AMENDMENT TO APPROVED MASTER PLAN APPLICATION

***Re: Transportation Master Plan Amendment Summary Letter
 McCoy Retreat Center
 San Marcos, Texas***

McCoy's Retreat Center
TMP Amendment

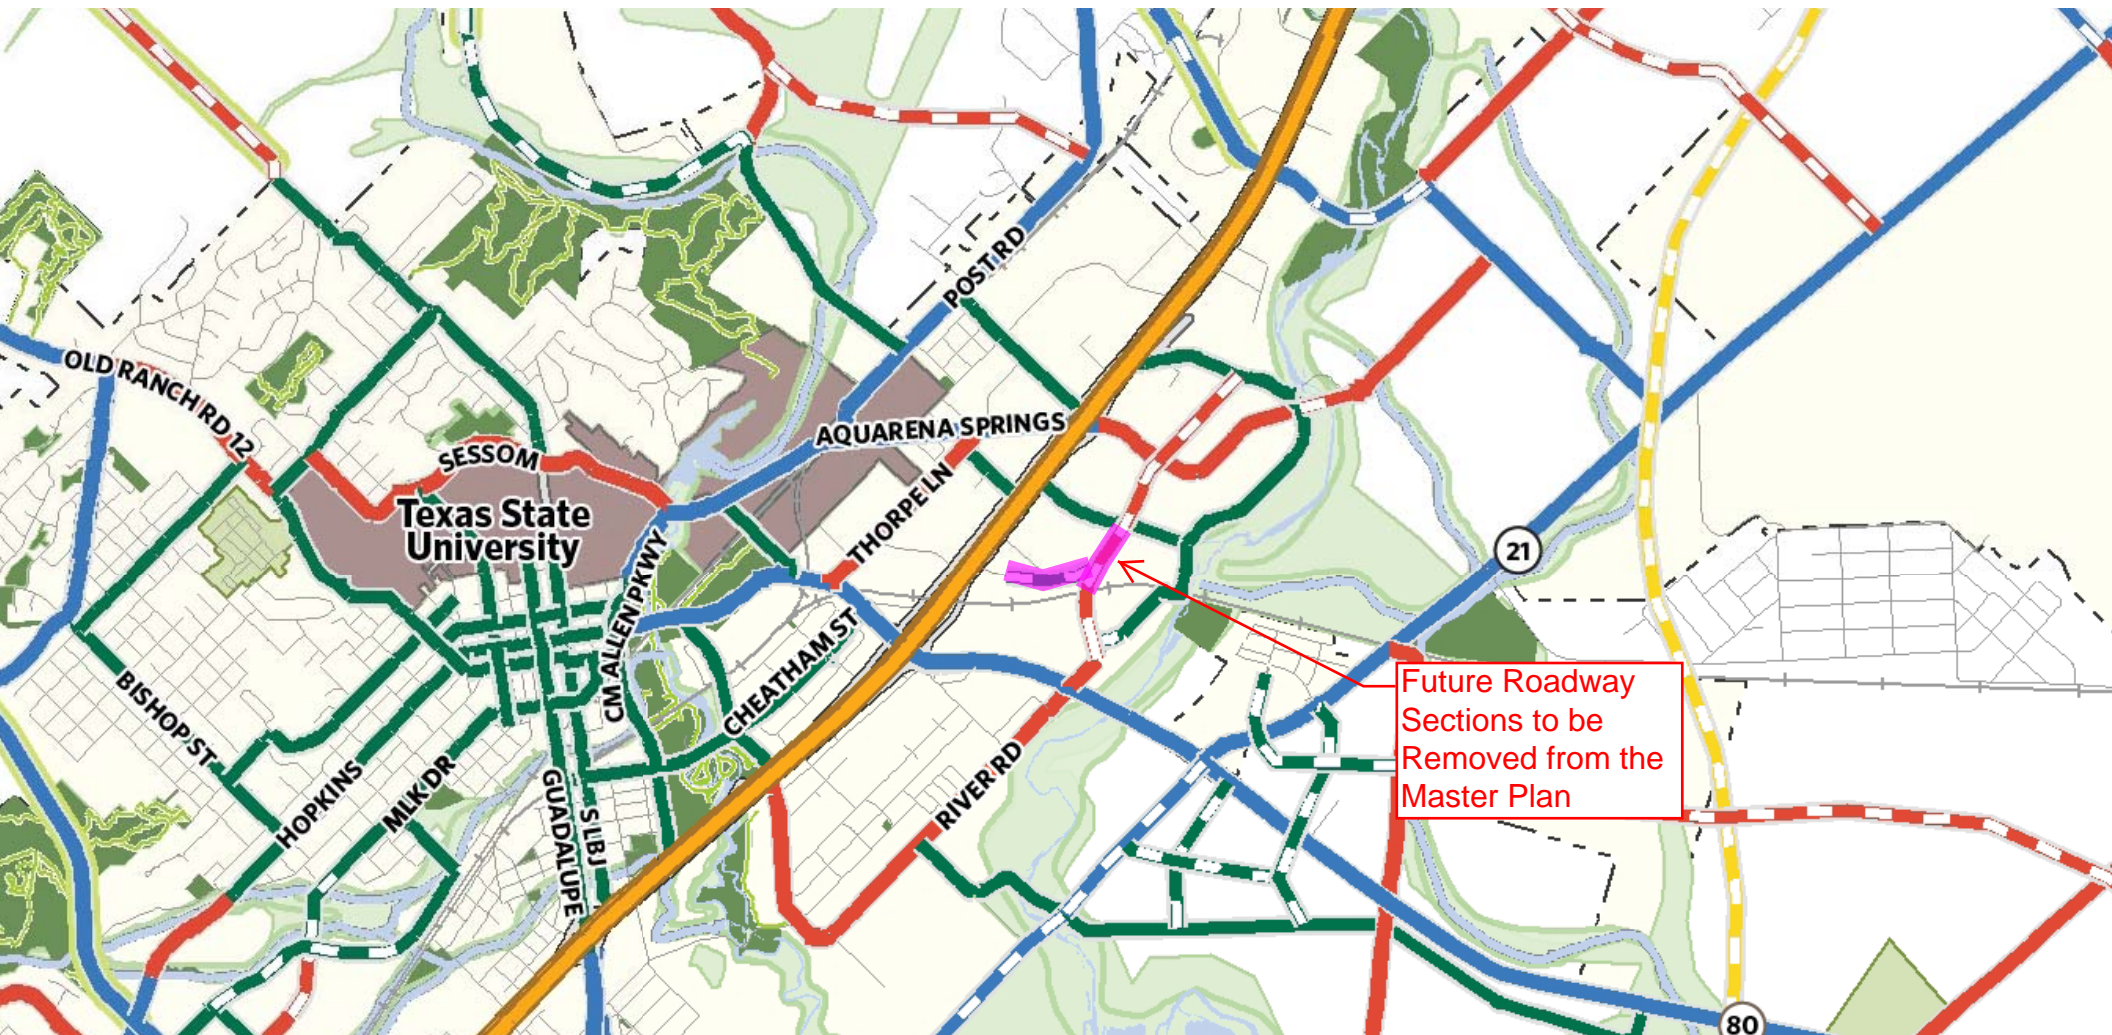
The TMP currently shows a Street extension through the heart of the site's oak groves that would connect McCoy Circle and the adjacent hotel development to Davis Lane. Additionally, the plan proposes a new Avenue that would run along the south side of the McCoy Office Subdivision Lot 2 connecting River Road to the south of the railroad to Davis Lane. The extension and locations of these proposed roadways would be in conflict with the intent of the proposed Retreat development. The new roads would further develop and pave over the natural landscape eliminating the private rural atmosphere of the subject

In summary, we respectfully request that the City amend the Transportation Master Plan to eliminate the proposed Street and Avenue extensions. Upon approval, our team will work closely with City Staff to comply with applicable codes and regulations for the subdivision and design of the project. If you should have any questions regarding this application or need additional information regarding the McCoy Retreat Center development, please feel free to contact us at 512-556-8160.

Highlighted Section
to be Removed
from Plan
